Structural Calculations For:

Mercer Island – Masuda Remodel

Supplemental Calculations for Permit

Review – 5/28/21 Comments

GRID 2 LATERAL CALCULATIONS CONT'D

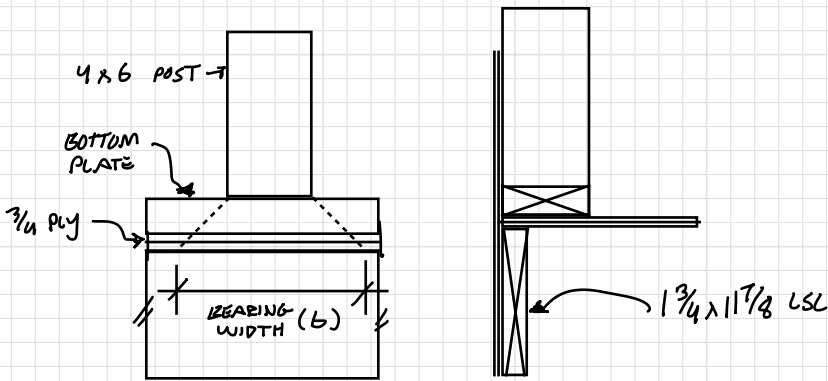
COMMENT ON PAGE 15:

$$V_{\text{ABOVE}} = 3.91 \text{ kips}$$

$$V_{\text{THIS LEVEL}} = \frac{1.9 \text{ k}}{2} = 0.95 \text{ kips}$$

$$V_{\text{TOTAL}} = 3.91 \text{ k} + 0.95 \text{ k} = 4.86 \text{ kips}$$

$$L_{\text{wall}} = 3'-6" + 2'-8" + 2'-8" + 3'-11" = 12.75 \text{ ft}$$

$$V_a = \frac{4.86 \text{ kips} \times 1000 \text{ lbs/kip}}{12.75 \text{ ft}} = 381 \text{ plf}$$

$$W2 \text{ CAPACITY (REDUCED)} = 498 \text{ plf} > 381 \text{ plf} \checkmark \text{OK}$$

$$O.T. = 381 \text{ plf} \times 9.83 \text{ ft} = 3364 \text{ plf}$$

(E) HDU 11 OR BY INSP. $\checkmark \checkmark$ OK
